Product Change Notification

Product Change Notification: E-20-015569

Modification PT relay base

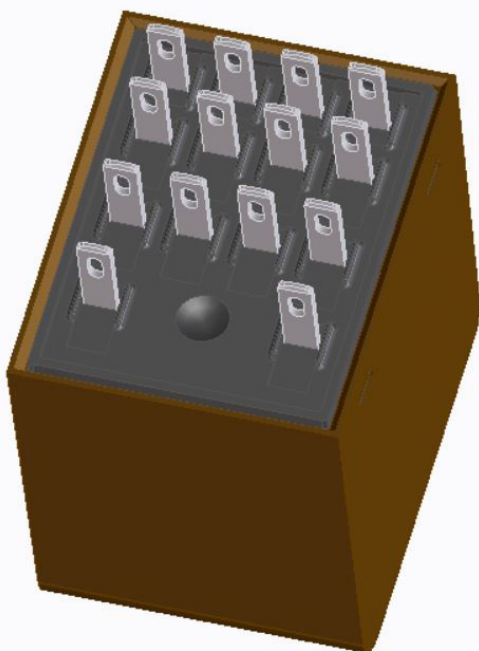
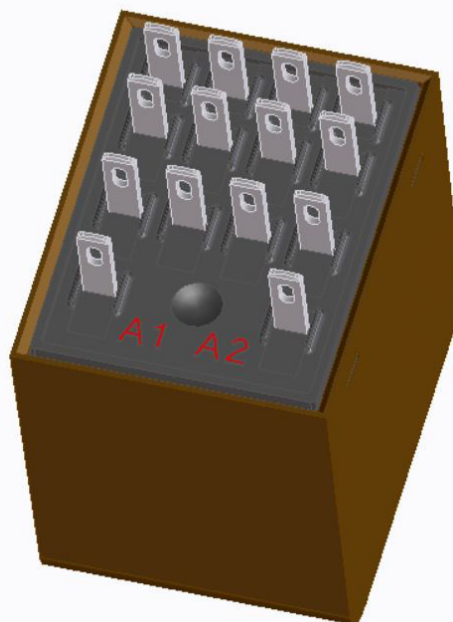
At the bottom of the relay base coil pin indicators were added, see red marked area. These indicators were added in the mold of the base and will protrude a maximum of 0.2mm. The modifications do not have any influence of the specification or behavior of the relay.

Product Improvement. This modification can help customers to identify the correct coil pins. Especially at coils with a protection diode the customers can assign the correct polarity.

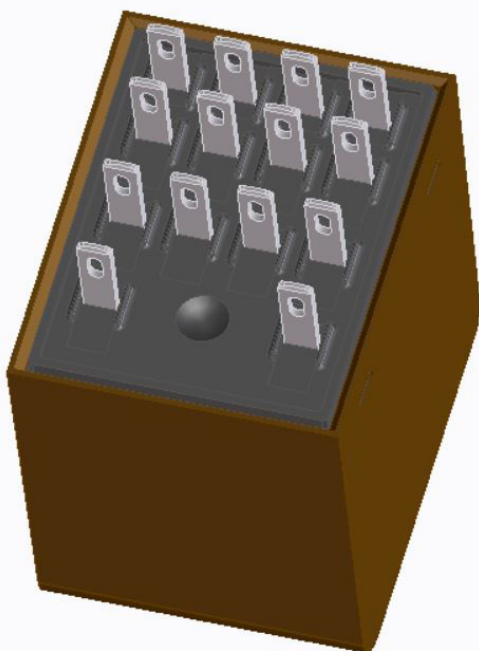
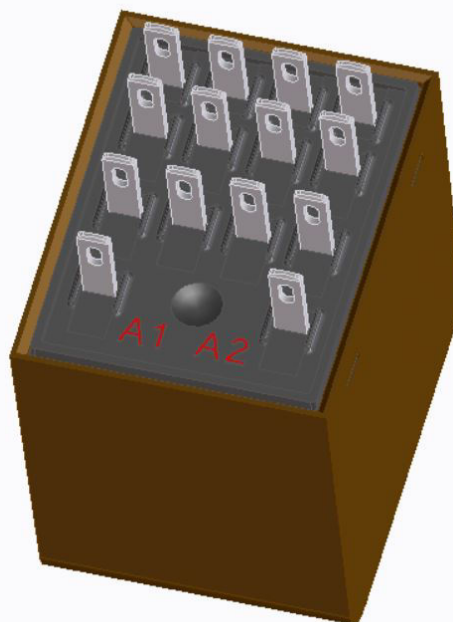
At the bottom of the relay base coil pin indicators were added, see red marked area. These indicators were added in the mold of the base and will protrude a maximum of 0.2mm. The modifications do not have any influence of the specification or behavior of the relay.

Product Improvement. This modification can help customers to identify the correct coil pins. Especially at coils with a protection diode the customers can assign the correct polarity.
